United States Patent and Trademark Office

APPLICATION NO.	FILING DATE	FIRST NAMED INVENTOR	ATTORNEY DOCKET NO.	CONFIRMATION NO.
10/542,359	07/14/2005	Shoichi Kikuchi	274618US0PCT	2815
22850 7590 07/31/2007 OBLON, SPIVAK, MCCLELLAND, MAIER & NEUSTADT, P.C. 1940 DUKE STREET			EXAMINER	
			MCNELIS, KATHLEEN A	
ALEXANDRI	A, VA 22314 ART UNIT P		PAPER NUMBER	
·		1742		
•				
			NOTIFICATION DATE	DELIVERY MODE
·		•	07/31/2007	ELECTRONIC

Application No.	Applicant(s)				
Office Action Summary		10/542,359	KIKUCHI ET AL.				
		Examiner	Art Unit				
		Kathleen A. McNelis	1742				
Period fo	The MAILING DATE of this communication app or Reply	ears on the cover sheet with the c	orrespondence address				
WHIC - Exter after - If NO - Failu Any r	ORTENED STATUTORY PERIOD FOR REPLY CHEVER IS LONGER, FROM THE MAILING DATE in the may be available under the provisions of 37 CFR 1.13 SIX (6) MONTHS from the mailing date of this communication. It period for reply is specified above, the maximum statutory period were to reply within the set or extended period for reply will, by statute, reply received by the Office later than three months after the mailing and patent term adjustment. See 37 CFR 1.704(b)

FIG. 15

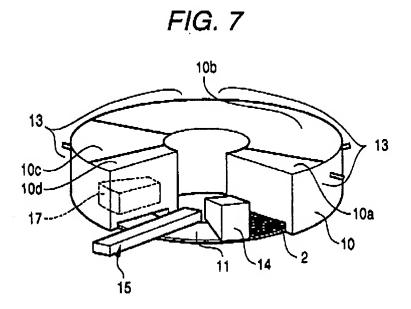
With respect to <u>claims 1 and 3</u>, Sawa et al. discloses a method for producing reduced metal by charging a raw material containing a metal containing material and a solid reducing material on a layer of solid reducing material placed on the hearth of a traveling hearth furnace, reducing and melting the material to separate metal from gangue and discharging from the hearth (abstract). Sawa et al. discloses iron ore as a reducible material (col. 6 lines 40-47). Sawa et al. discloses reducing, melting and cooling the raw material (col. 3 lines 4-35). Figure 7 shows a generalized layout of the furnace comprising charging device (14) preheating zone (10a), reducing zone (10b), melting zone (10c), cooling zone (10d), cooler (17) and discharging device (15). Figure 15 shows a detailed view of the charging device comprising charging device of solid reducing material (14-

2), charging device of raw material (14-2) and roller (14-3). Since the direction of travel is from the charging device through preheating, reducing, melting and cooling prior to discharge, the position of the discharged device (15) is downstream of the charging device (14) with respect to the direction of travel of the hearth (col. 6 lines 47-57 and Figure 7). Since the solid reducing material (1) is place as a lower layer between the raw material mixture containing iron ore (Fig. 2), the charging device for solid reducing material (14-2) is upstream of charging device for raw material (14-2) and the roller (14-3) is between the two (Figure 15) in the direction of flow of the hearth.

Sawa et al. discloses an embodiment where the solid reducing material layer is discharged at least partially or entirely (col. 14 lines 46-58). The roller (14-3) in Sawa et al. would level the surface of the newly formed hearth.

With respect to <u>claim 5</u>, the roller (14-3) is positioned across the direction of hearth movement (Figure 15) and therefore intersects the moving direction of the hearth.

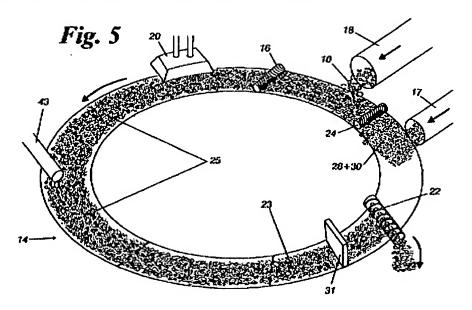
Figure 5 shows a schematic representation of the process where a mixture of refractory compounds (30) and carbonaceous materials such as graphite, anthracite coal, petroleum coke and

coke breeze (29) and refractory compounds such as silica, alumina and magnesia (30) are discharged from a position (17) which is upstream of the location for charging the pre-reduced metallized iron (10). A smoothing device (24), preferably an auger-screw device is located between the charge location of the carbonaceous and refractory compounds and the pre-reduced iron. The metallized iron, carbonaceous and refractory materials are removed by discharge device (22) (cols 5-8). The smoothing device levels the material.

With respect to <u>claim 5</u>, the smoothing device (24) is positioned across the direction of hearth movement (Figure 5) and therefore intersects the moving direction of the hearth.

With respect to <u>claim 6</u>, Figure 5 shows that the discharge mechanism is in a direction intersecting the moving direction of the hearth therefore iron and slag are discharged in the moving direction concomitant with the moving.

With respect to <u>claim 8</u> Hoffman et al. discloses continuous addition of hearth material and smoothing (cols. 5-8 and Fig. 5).
